BLM SCALAR FIX -Based on findbhudda's original design:
<http://www.midibox.org/dokuwiki/doku.php?id=findbhudda>

DESIGN FILES:

Corrected blm-scalar v1.1.brd bellow & attached [blm-scalar_v1.1.brd.zip](#)

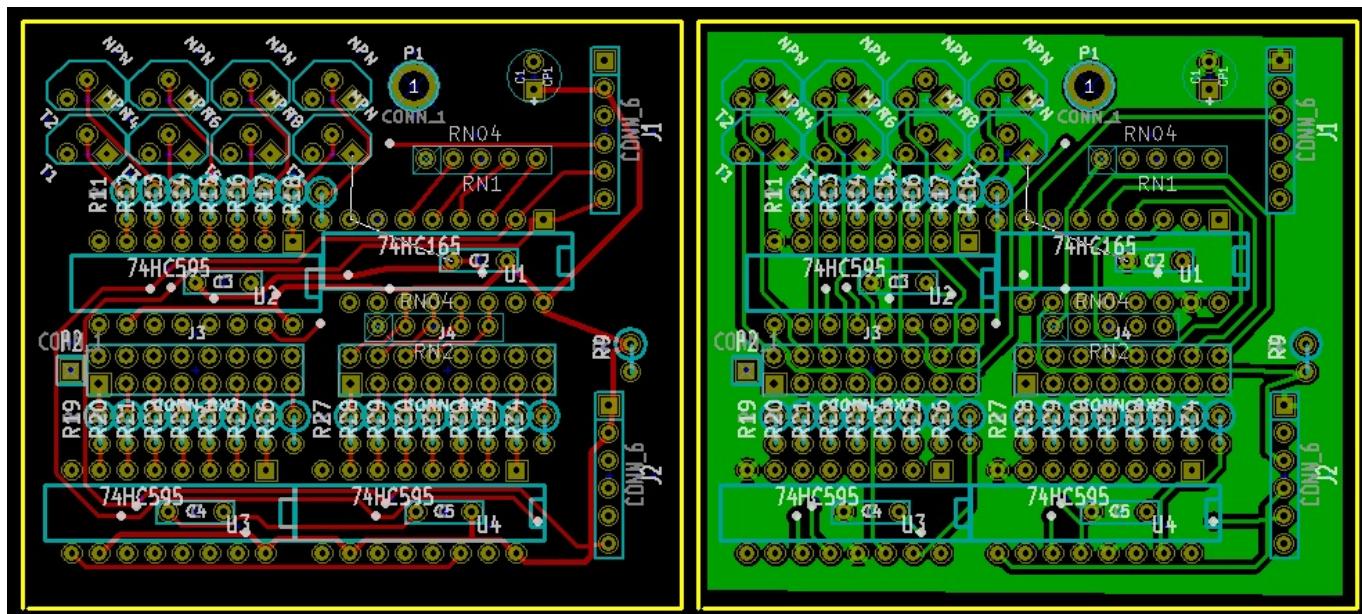
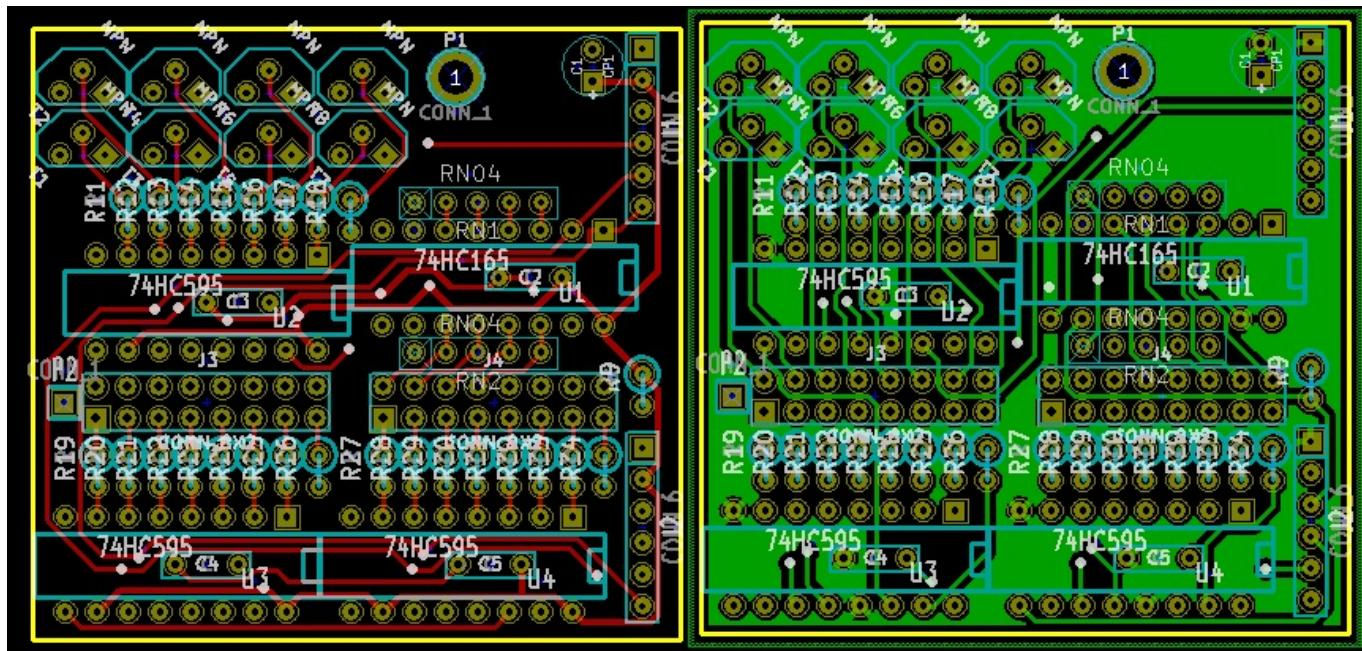
- blm-scalar.* contain an error. Pins I4-I7 are mirrored. This is easily fixed with a connector modification, and the blm-scalar module seems to work as intended.
 - blm-scalar v1.1 attempts to fix this error. Moved connectors J1, J2, Resistor Net 1 and R9 to make room for corrections.
-
